From: Mcconnell, DAVE P <dave.p.mcconnell@lmco.com>
Sent: Friday, April 27, 2018 7:48 PM
To: Grant Robinson
Cc: Mrazik, Philip
Subject: HTH Start Tube Chafe Repair

Case Number: C0093487
Customer: Thai Aviation Services Limited
Aircraft S/N: 920146
Aircraft Model: S-92A
Aircraft TT: 6,149
ATA: 21
Part Number: 92306-04102-052
Case Subject: Engine Start Tube Chafe-Request For Repair Scheme

Tube, No. 2 Engine Start
P/N 92306-04102-052
S/N Obliterated

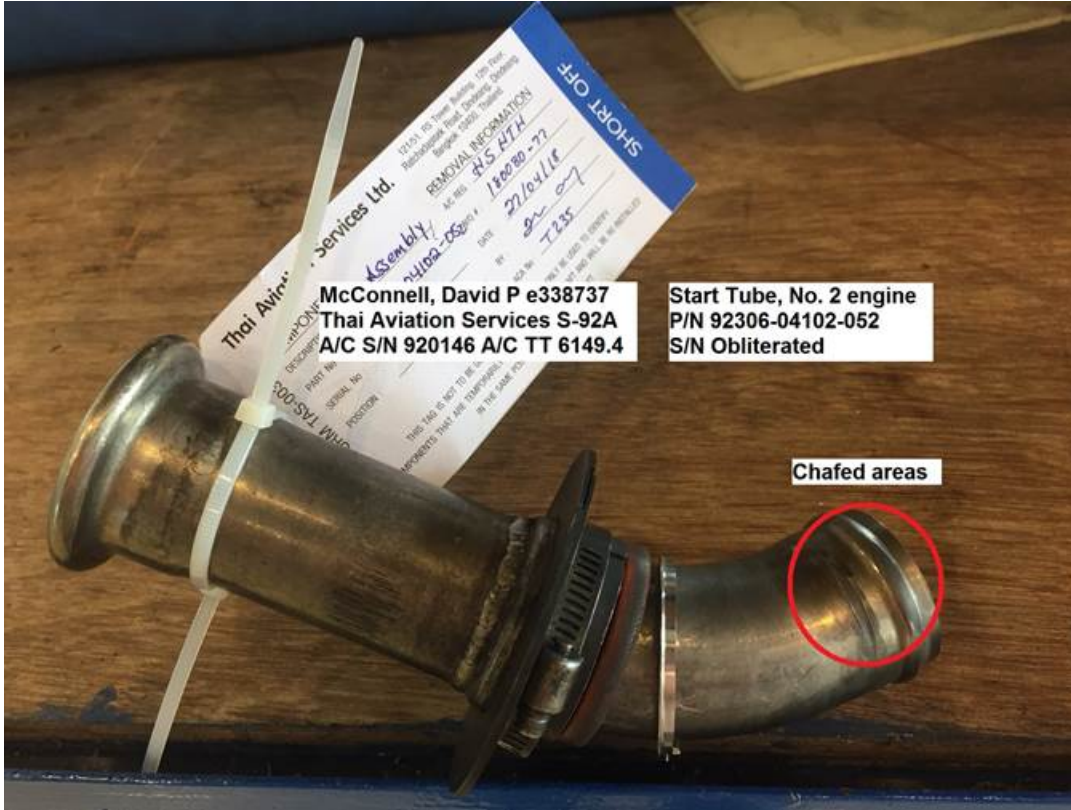
TAS maintainers removing the 5-pack on A/C S/N 920146 noted chafing damage on the P/N 92306-04102-052 No. 2 engine air start tube.

The chafed area measures 1.00 inches long x 0.100 inches wide inches. Depth is approximately half the wall thickness at the deepest point.

There is also a 1.00 inch long flattened area on the bead adjacent to the chafe.

There are no perforations and no cracking is noted.

As a precautionary measure in order to avoid a potential AOG situation TAS request SA approval on a Work Stop basis to perform a weld fill repair in the chafed areas, similar to the procedure called out in DRB 2017-SA-92-090. EoM

Sikorsky Engineering approves the use of DRB 2017-SA-92-090 to perform a weld fill repair on S/N 920146
